Wright-Ryan Construction Inc
REQUEST FOR INFORMATION

PROJECT: Oak Street Efficiencies
JOB: 1104

SKM-2

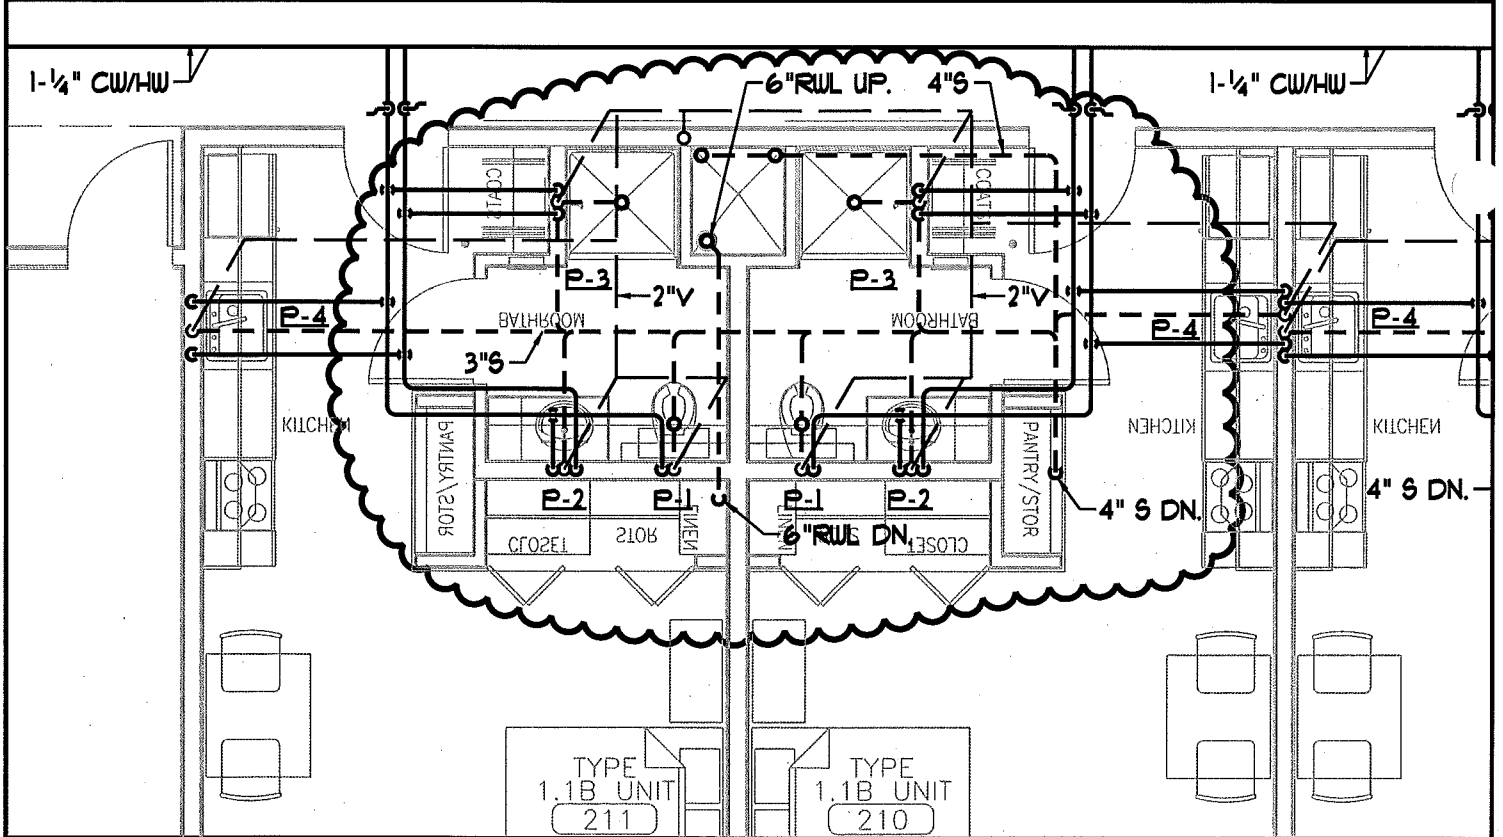
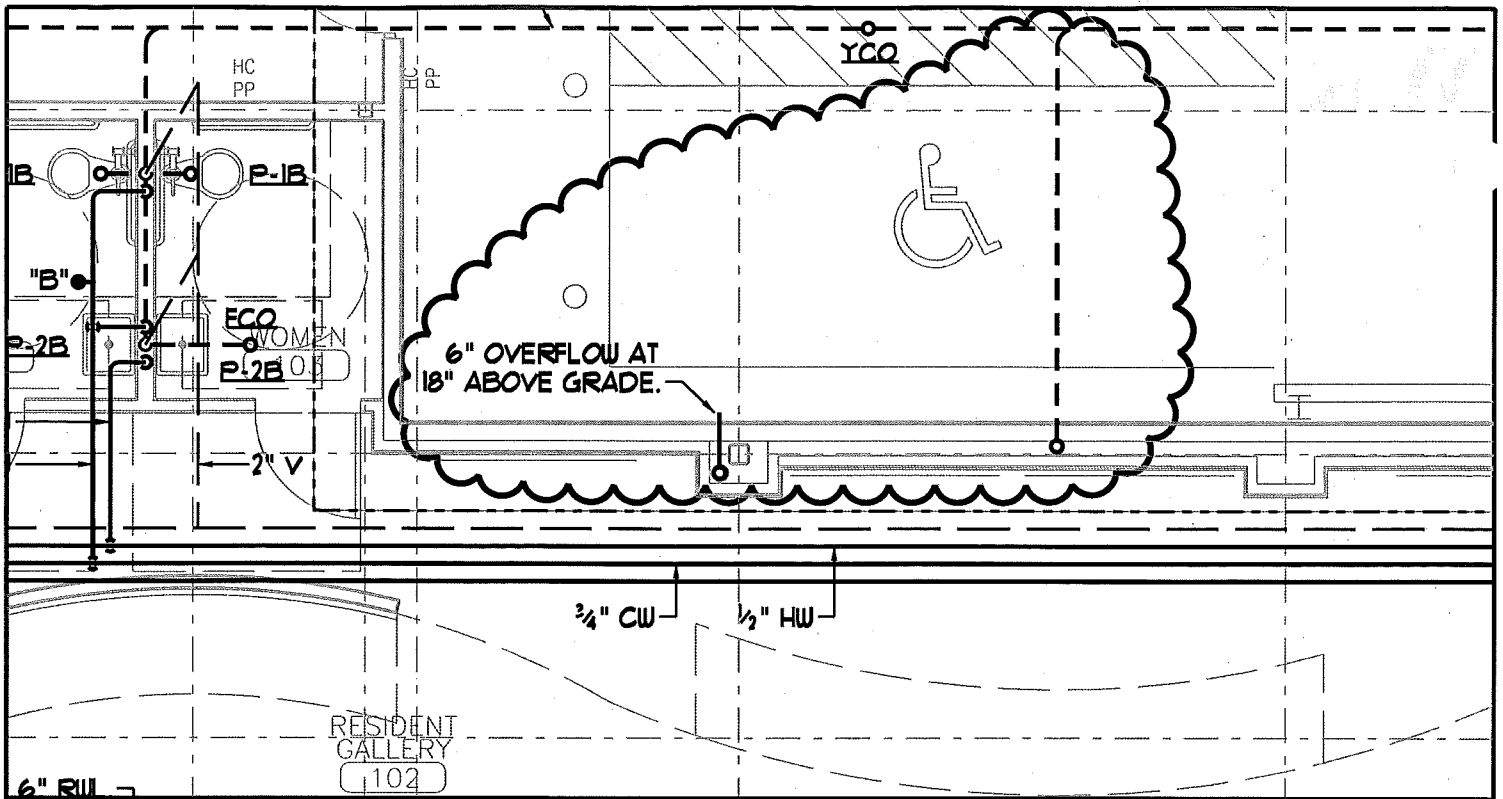
Please refer to Drawing M2.1.

The sanitary line coming down from Unit 211 may cause a conflict with wall dimensions.

May we move it over roughly 18' to avoid a conflict in the wall?

The sanitary line may be relocated as requested. Additionally, please note that the roof overflow drain outlet located in the same area shall be installed to discharge ABOVE the top of foundation wall. Please see SKM-2, attached

SKE-3

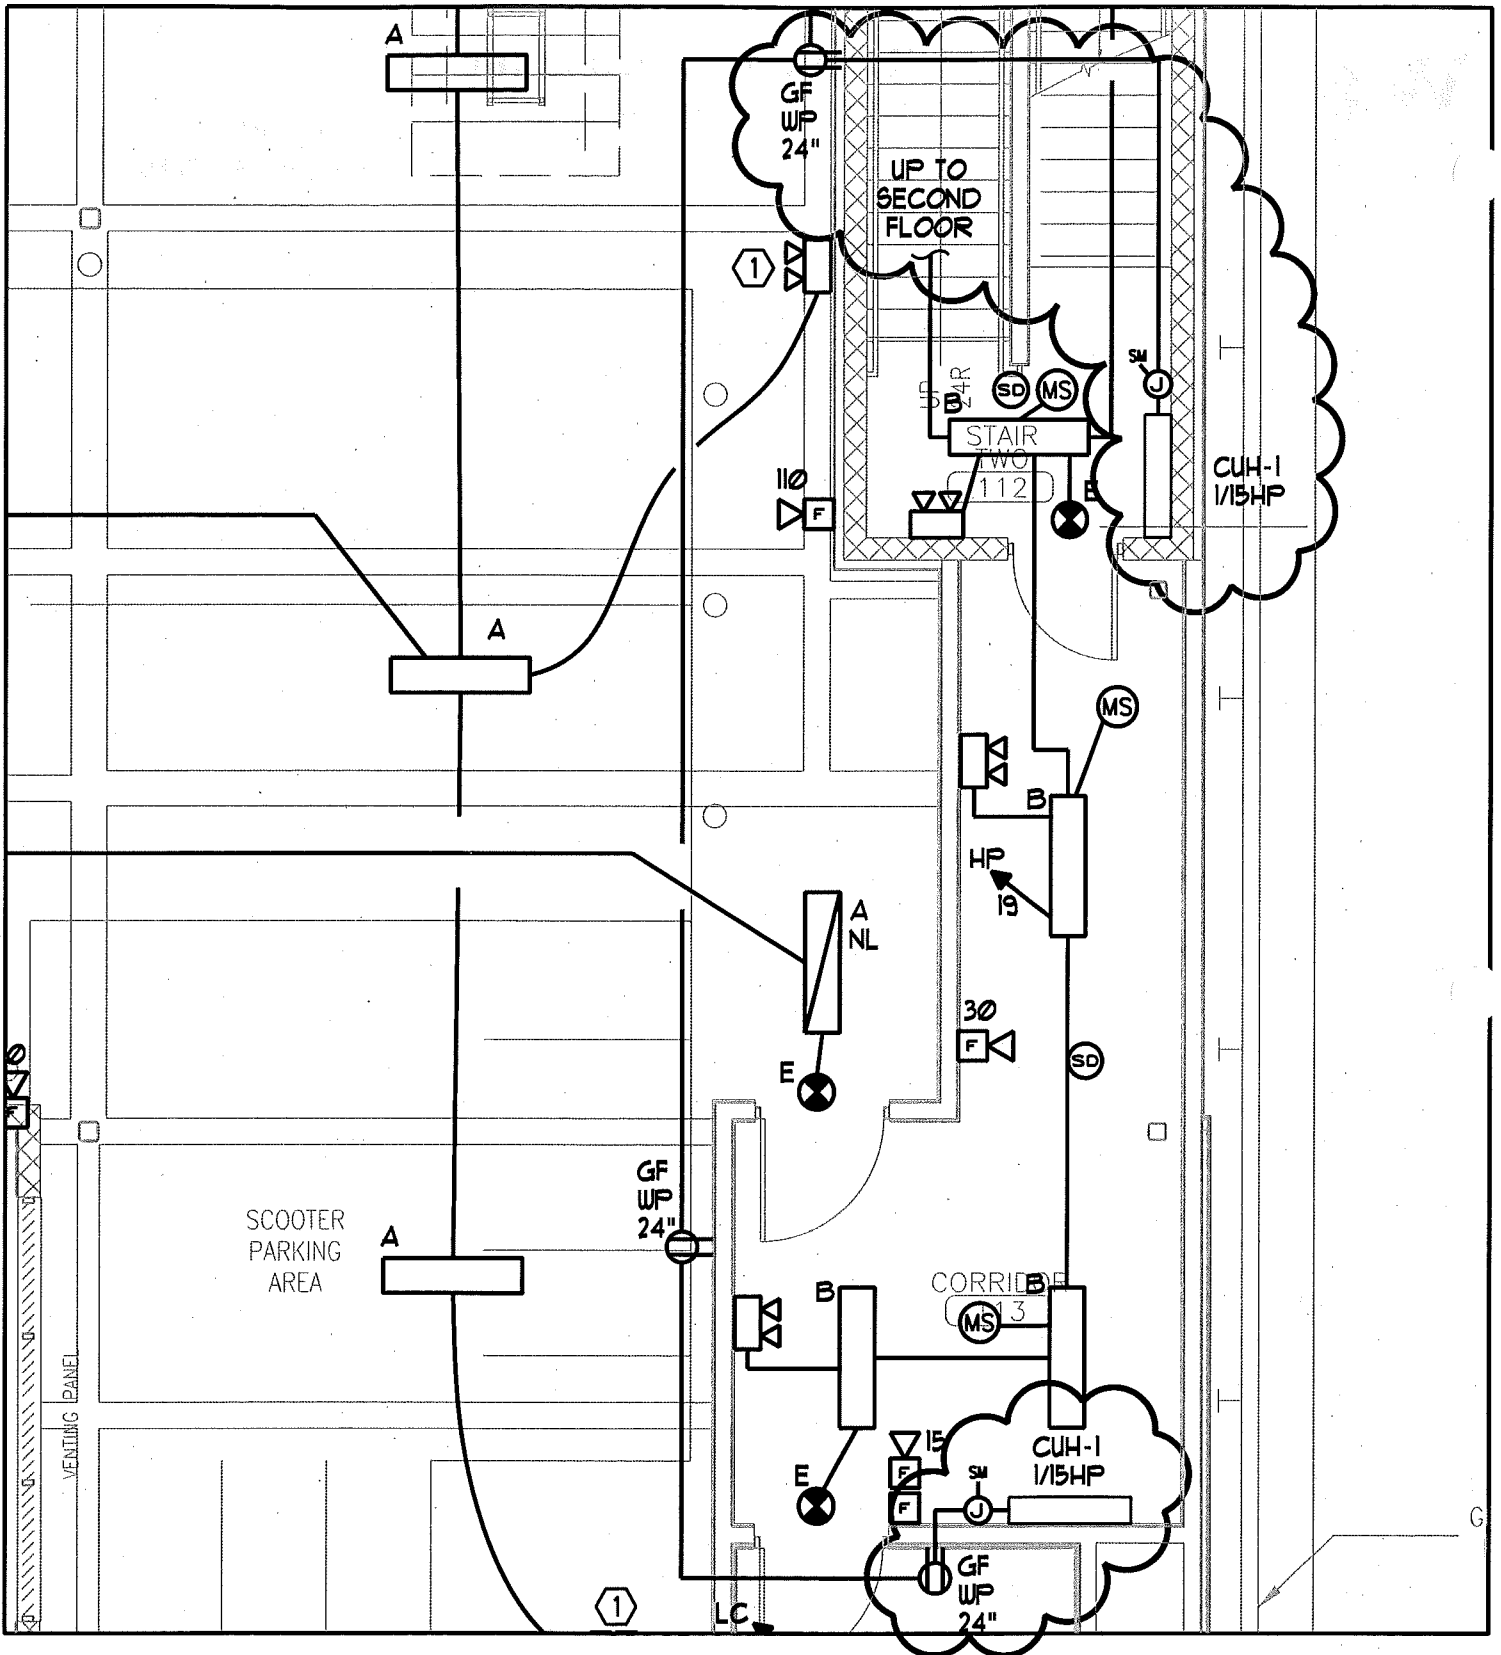
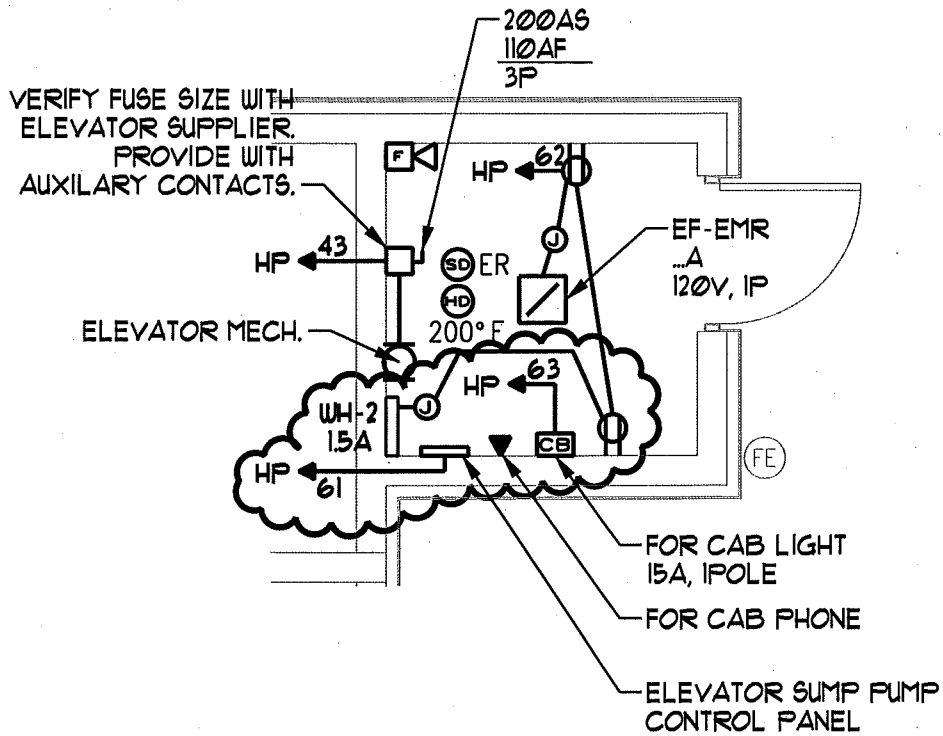
The mechanical drawings call for a heater in the elevator machine room and another heater in stair two. The electrical drawings do not show these heaters.

Please advise what circuits these heaters are on.

Please see the attached SKE-3 and SKE-4 for wiring information.

CSK 06

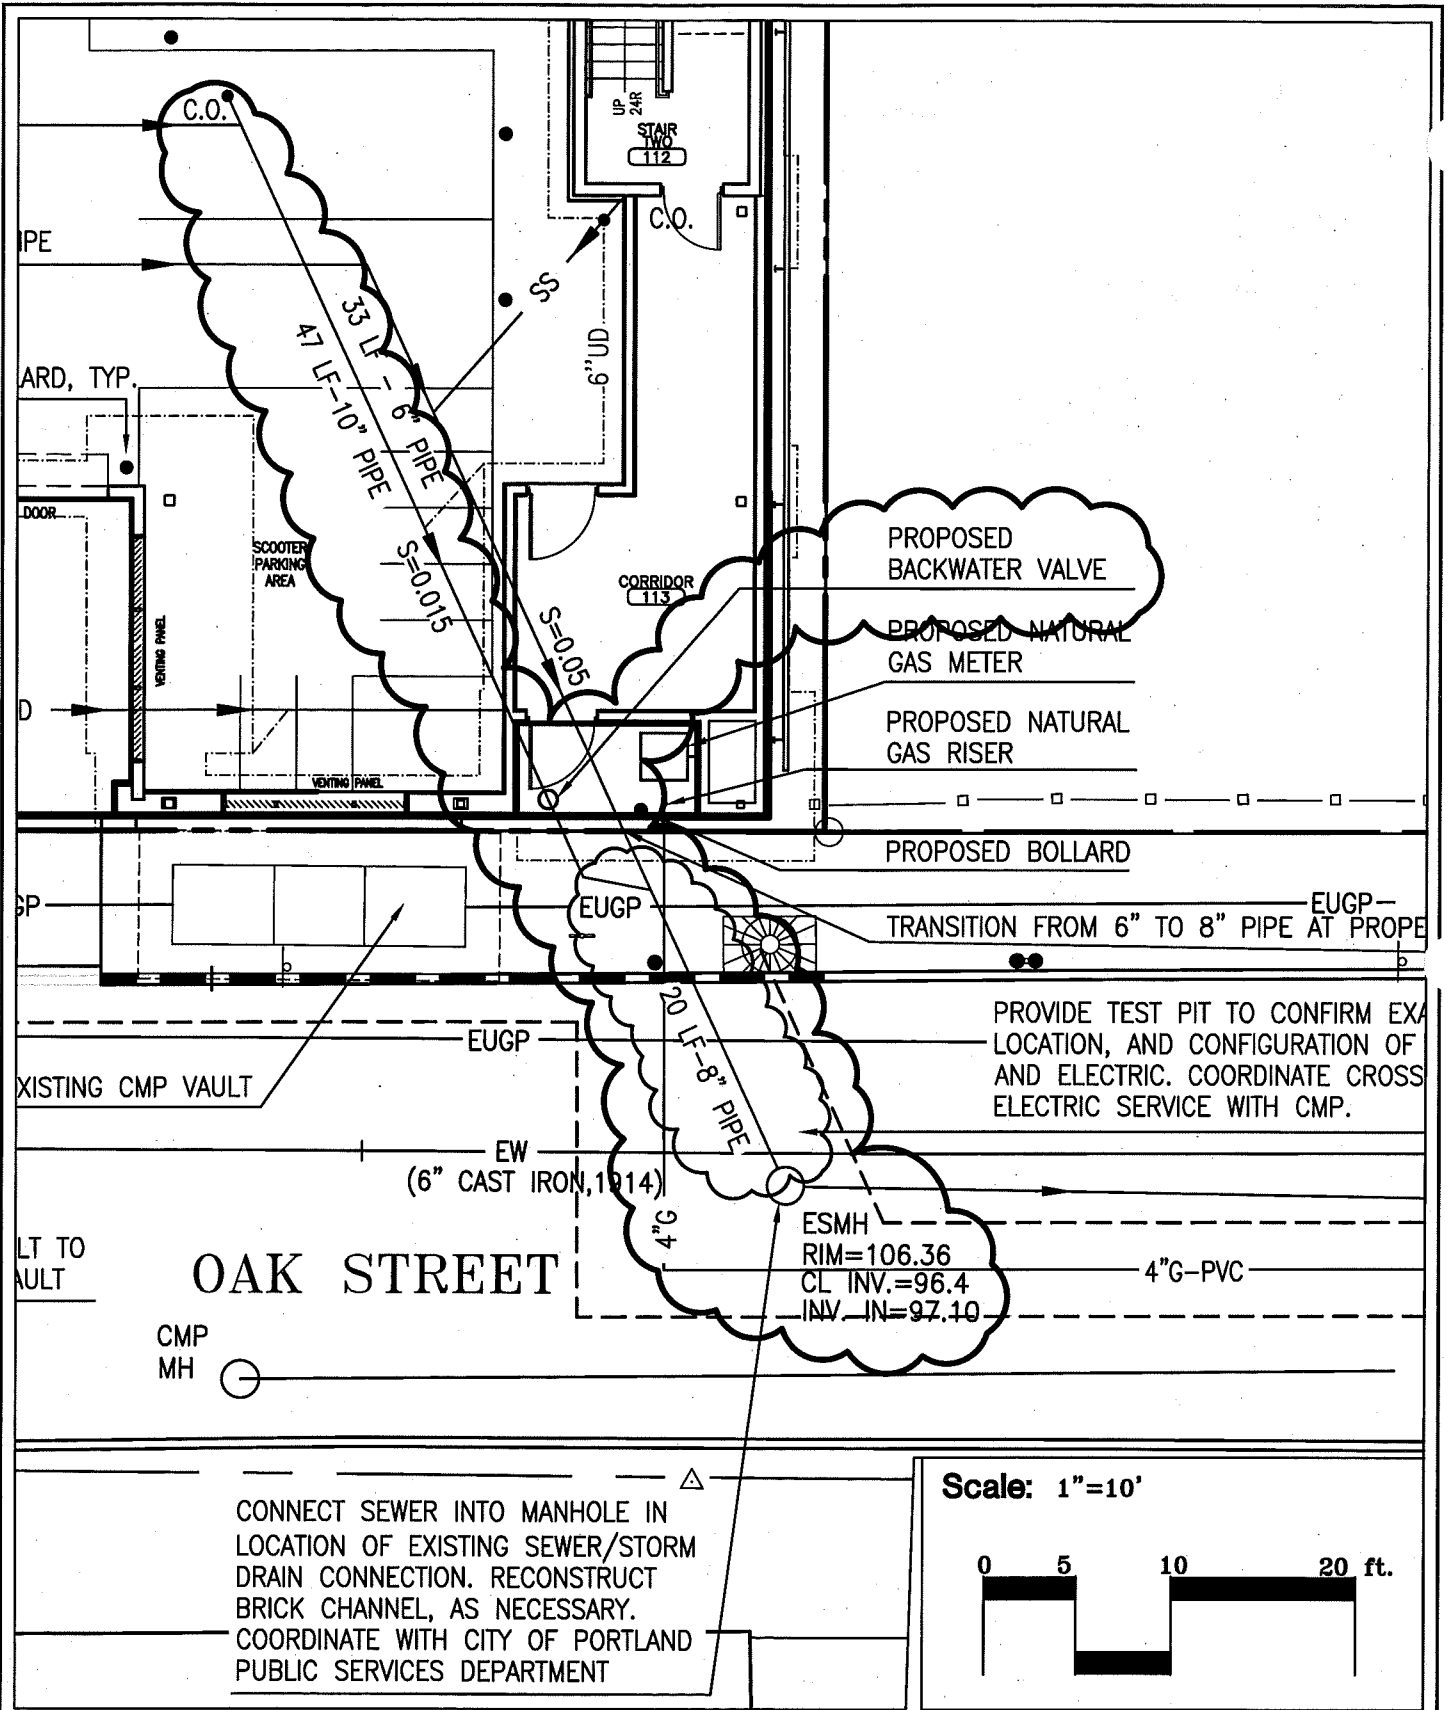
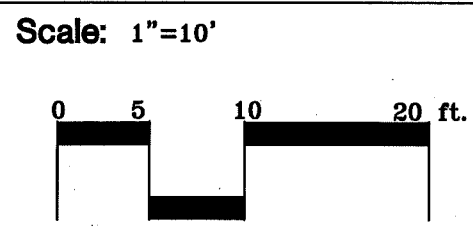
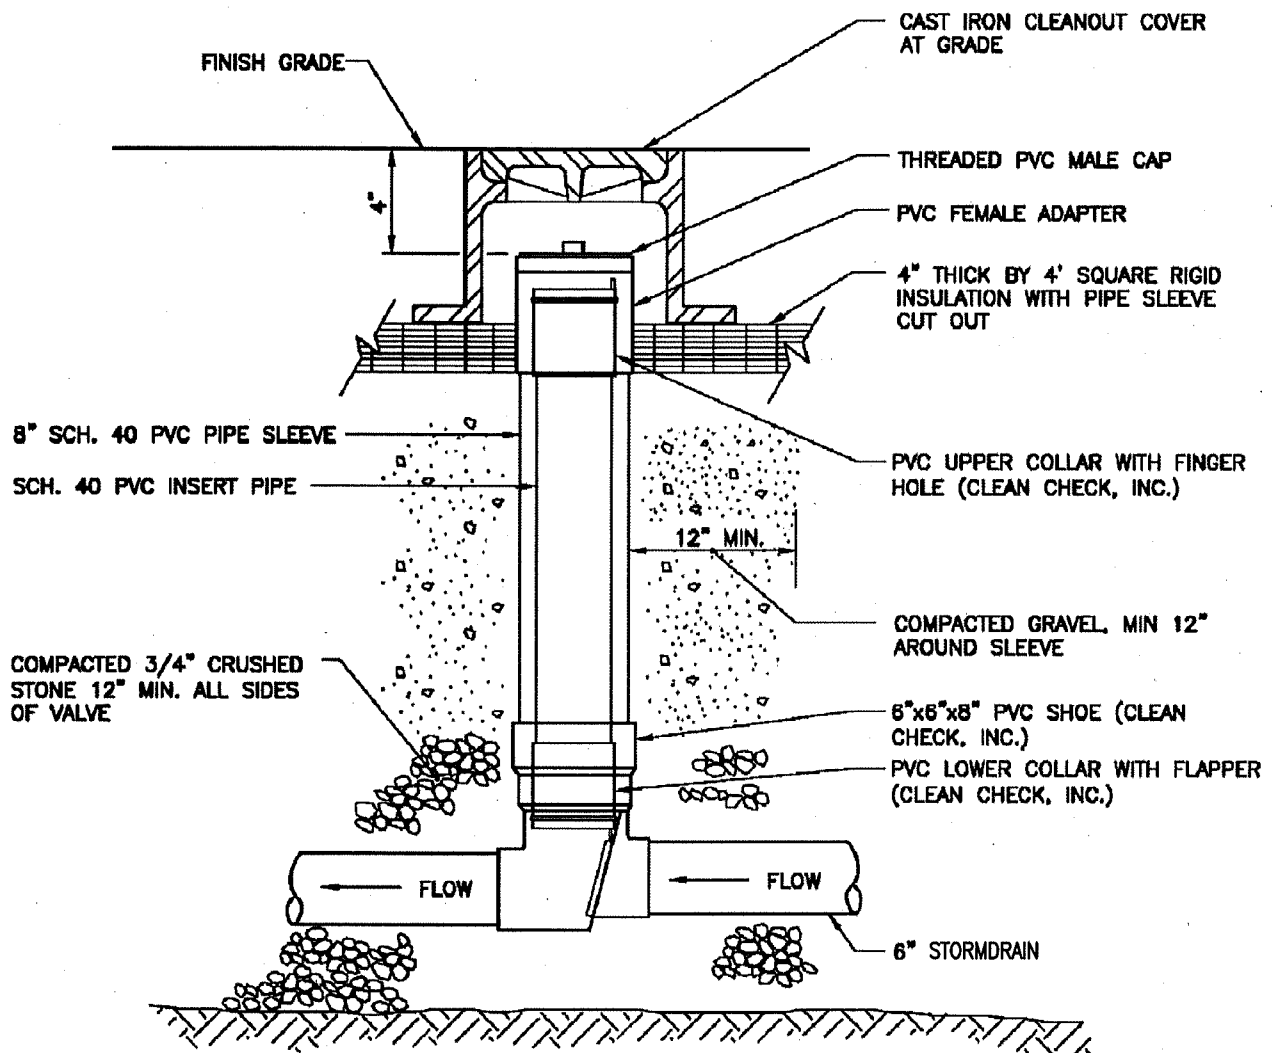
Because of multiple existing electrical vaults and the existing water-main running down Oak Street, we are requesting that the sewer and storm water lines be combined just outside the foundation. This would allow us to make only one penetration into a deteriorating sewer manhole. In addition, is a back flow preventor needed or any other type of prevention.

Please see attached sketches (CSK-06) for reconfiguration of stormwater and sewer lines. A Backwater Valve has also been added on the stormwater line.
